SUBJECT: Watts Bar Nuclear Plant - FSAR REVISION PACKAGE NO. 385

SUBJECT: WATTS BAR NUCLEAR PLANT - STEEL CONTAINMENT VESSELS FOR THE REACTOR BUILDINGS - EFFECT OF MASS ECCENTRICITY ON RESPONSE SPECTRA

WATTS BAR NUCLEAR PLANT  
INDEPENDENT REVIEW

SUBJECT: WATTS BAR NUCLEAR PLANT - MULTIPLE SUPPORTS ATTACHED TO EMBEDDED PLATES -  
NCR WBNCEB8203 R1

FIGURE 1

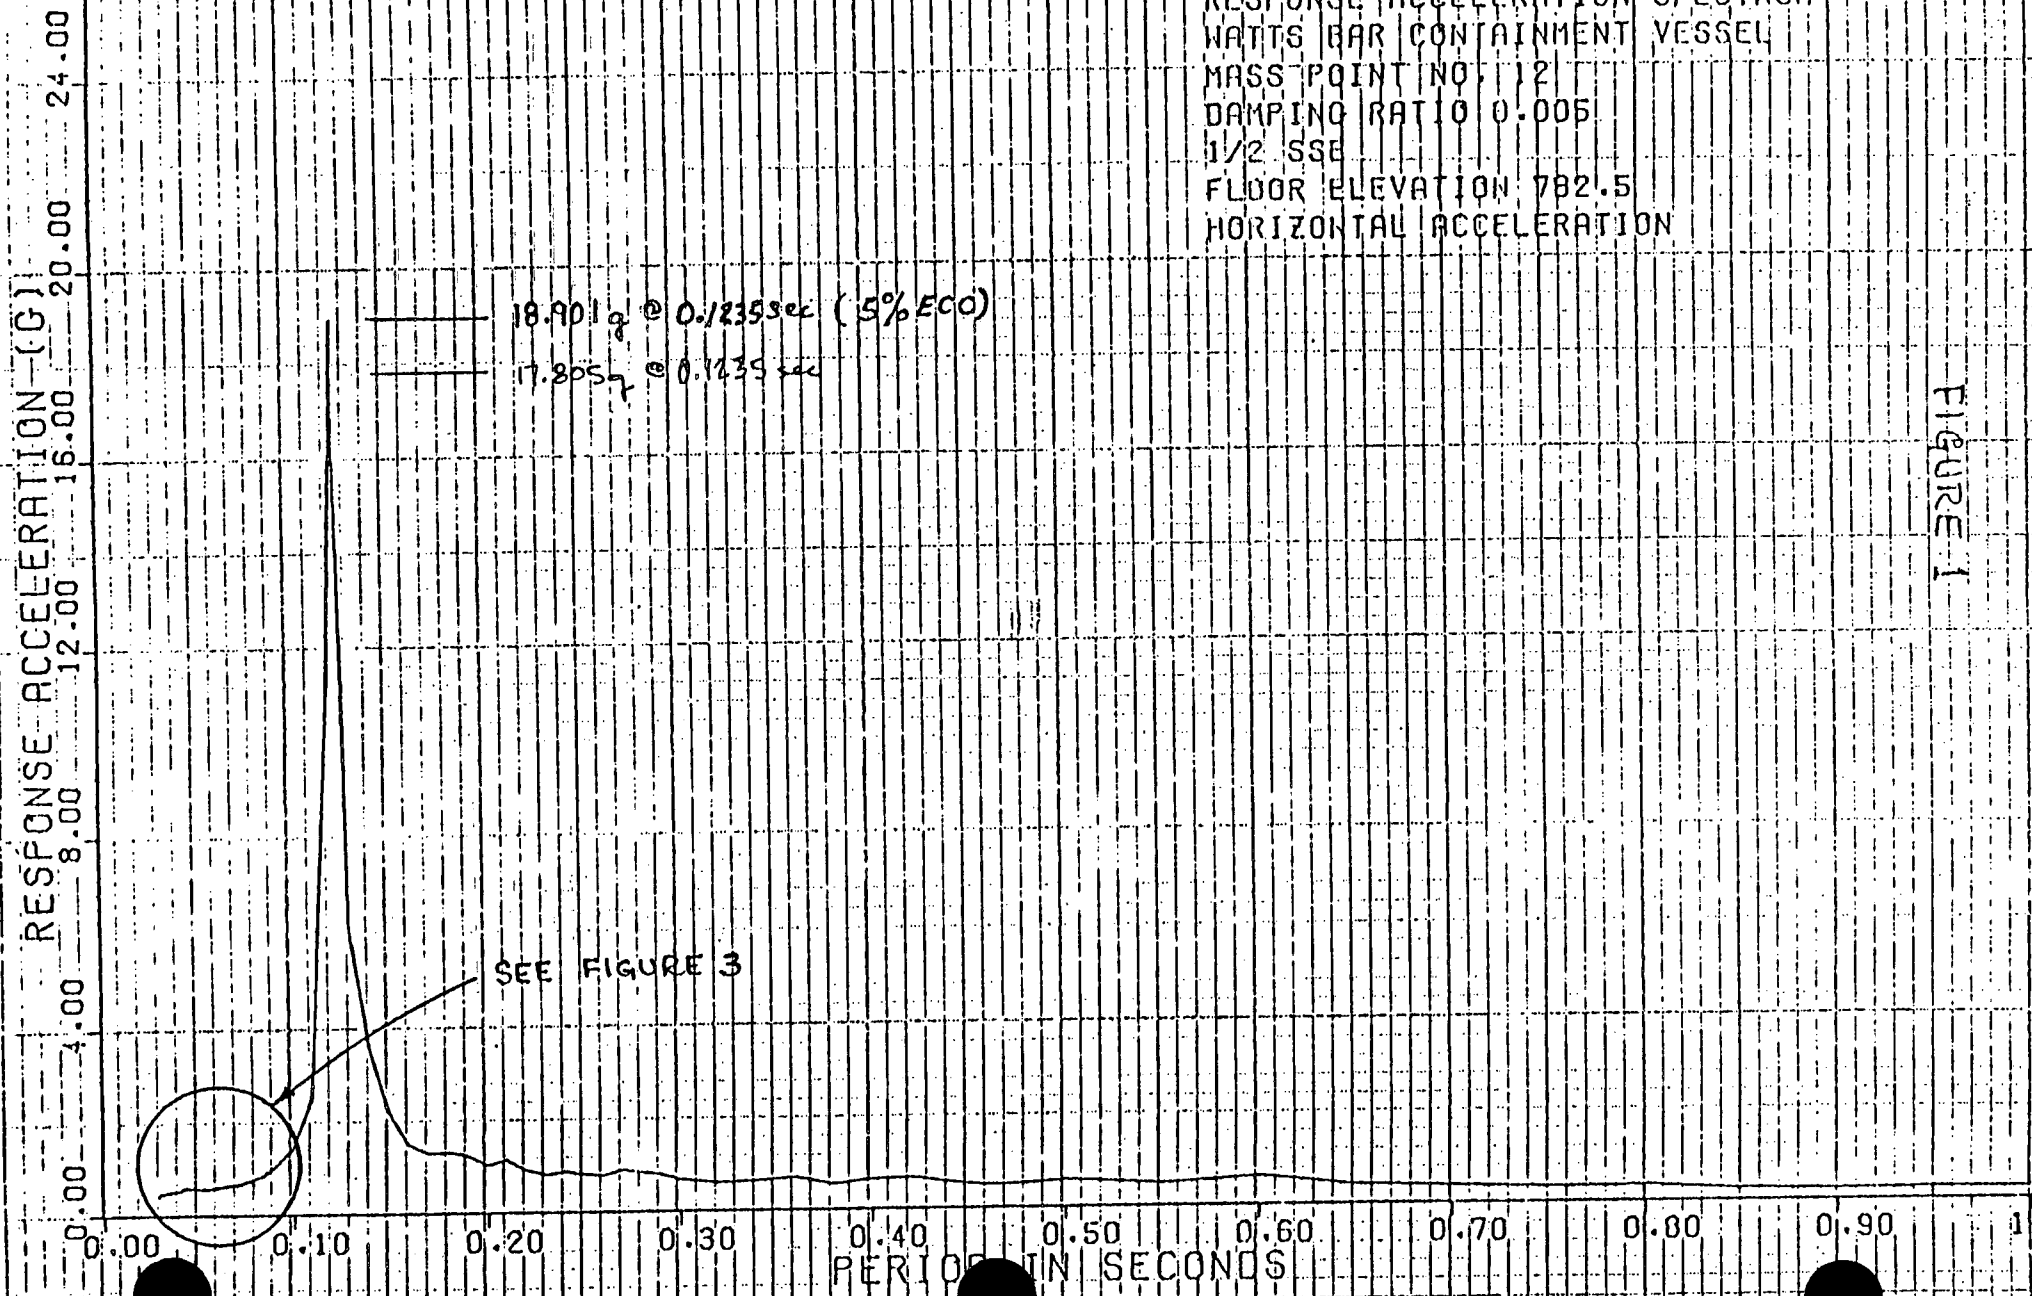
Figures 1 and 2 present copies of response spectra from the original analysis with the corresponding spectra from step 1 of this analysis superimposed. With the scale factors used on these figures, the only point which shows a significant change is the peak acceleration. Note also that the difference which is shown reflects the effects of both the increased eccentricity and the increase in response in moving from the mass center to the surface of the SCV.

PROJECT WBNP CONTRACT 74C38-830  
 DRAWING # 03B-1AFW-R231  
 SHEET 1/1 REV 903 UNIT

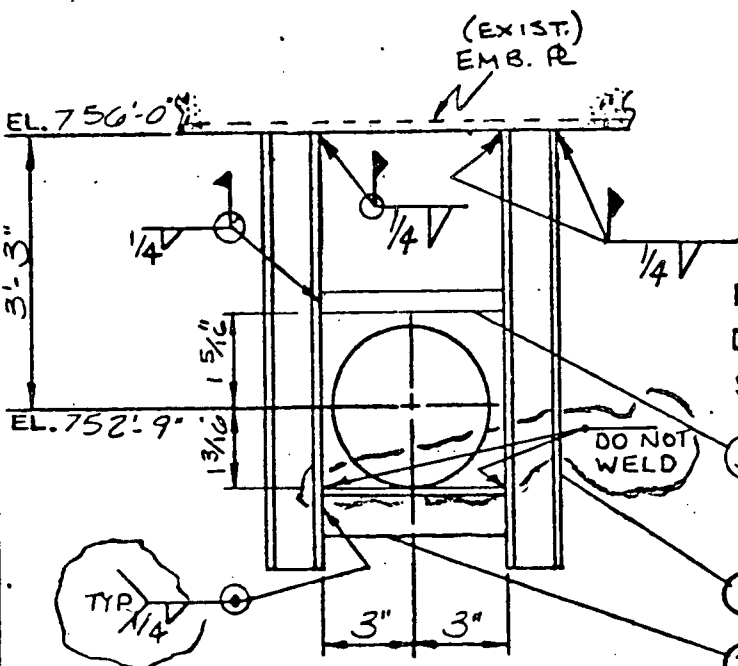
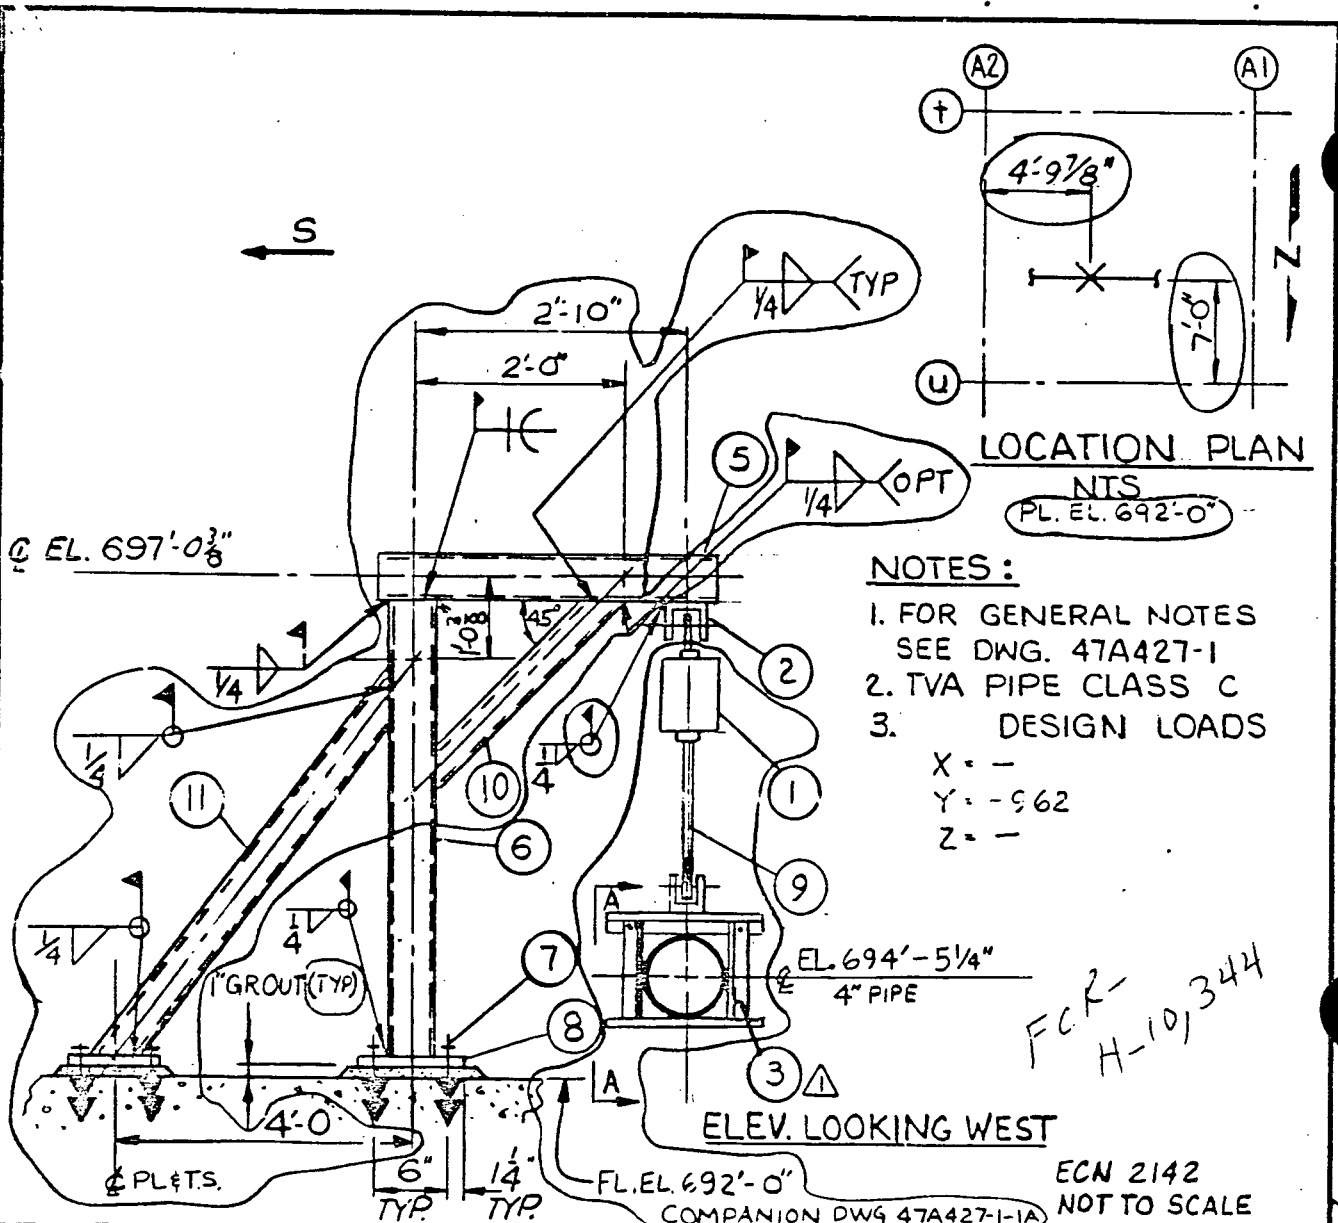
TVA agreed that the missing weld for item 1 existed and that the configuration did not match drawing 03B-1AFW-R231 Rev 0 for the welds for item 1. This was documented by TVA on Construction NCR 4455R (copy attached). The NCR did not address the missing welds for item 2. EN DES dispositioned the NCR use-as-is and drawing 03B-1AFW-R231 was revised on Rev 902 (copy attached) to agree with the as-installed configuration of the hanger. The NCR and the Rev 902 of the drawing shows the upper left attachment welded all around and the upper right attachment welded on two sides (not welded on the east and west sides).

The missing weld for item 2 was not initially responded to by TVA, but subsequently drawing 03B-1AFW-R231 was revised on Rev 903 (copy attached) to reflect that the welds identified by B&V as missing are not required. This was discovered during a 79-14 review and the drawing was revised.

PROJECT WBNP CONTRACT 74C38-83015  
DRAWING # 03B-IAFW-R188  
SHEET 2/2 REV. 904 UNIT 1

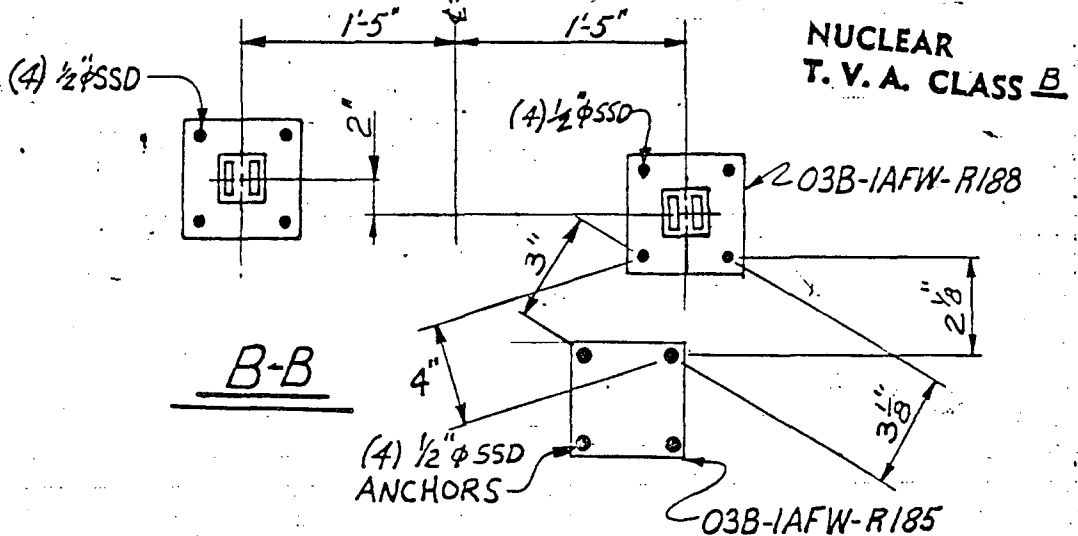
The design of support 03B-1AFW-R188 R901 would not allow for a secure tightening of the U-bolt and therefore would not allow for adequate restraint. Per disposition of NCR WBNSWP8305, support 03B-1AFW-R188 R904 was voided on 8/10/83 under ECN 3511. A new, more stable structure which allows proper tightening of the U-bolt and will adequately restrain the pipe was designed and issued as drawing 47A427-4-5 RO on 8/10/83 under ECN 3511. All corrective action for the finding is complete. The NCR is scheduled to be closed by 12/15/83.

PROJECT WRAP  
 CONTRACT 83015  
 DRAWING# 03B 2AFW R222  
 SHEET 1/1  
 REVISION 0  
 UNIT 2

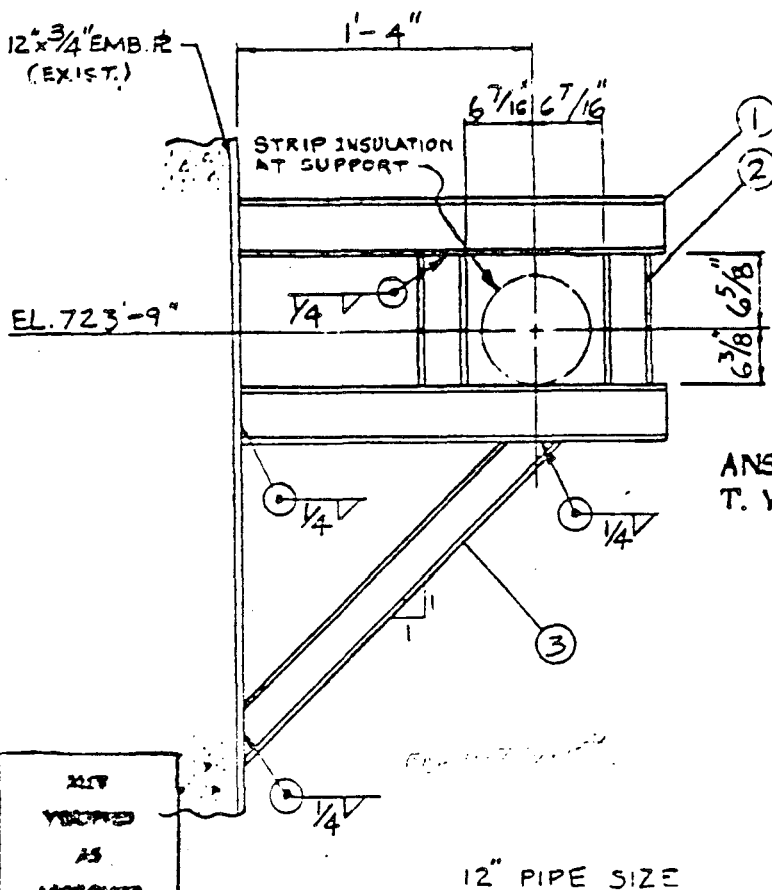
F782 - The TVA submittal addresses certification of the hanger to FCR 7598, but the changes defined in Form 1 do not appear to have been made; and the hanger drawing 03B-2APW-R222, which was forwarded by Form 3, still shows the brace. Please clarify the submittal.

NCR 4486 R  
ATTACHMENT 1 OF 2

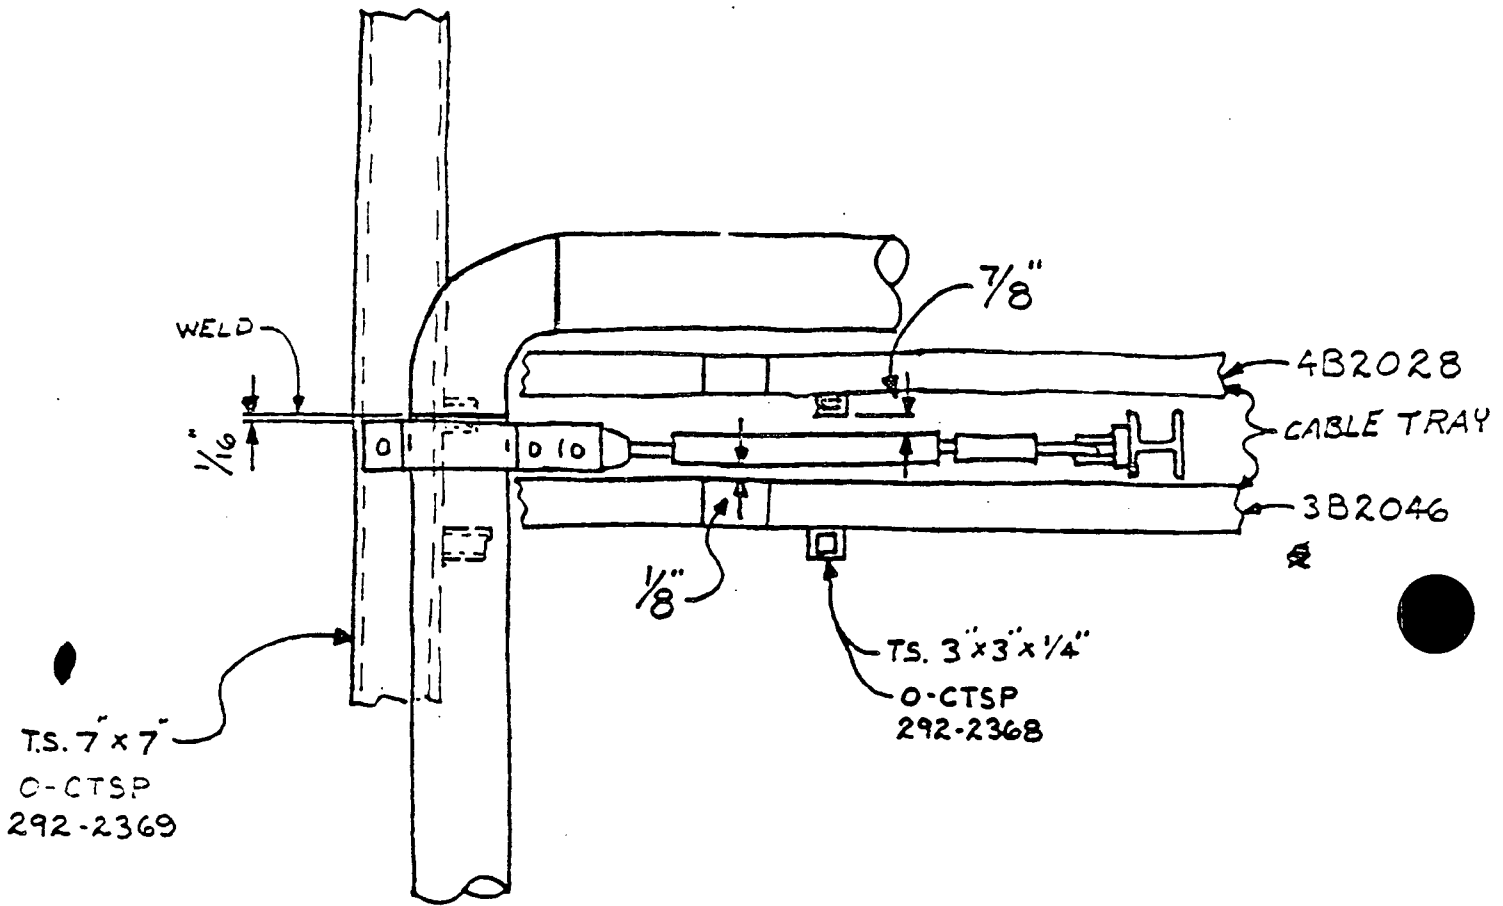
The support clamp has only 1/8" clearance with existing tube steel which will interfere with thermal movement of pipe in the "X" direction. The support strut (item no. 1) has only 1/8" clearance with a cable tray which will impede thermal movement in the "Y" direction (reference: support load drawing 47B-427-513 R/O).

The cable tray support will be moved 2 inches away from the pipe; civil drawings 48W1296-1 and -3 will be revised to show new location of the affected supports. The cable tray will be moved down 2 inches to clear any vertical movement of the pipe. Conduit and grounding drawing 45W880-12A will be revised to show new elevation of the cable tray.
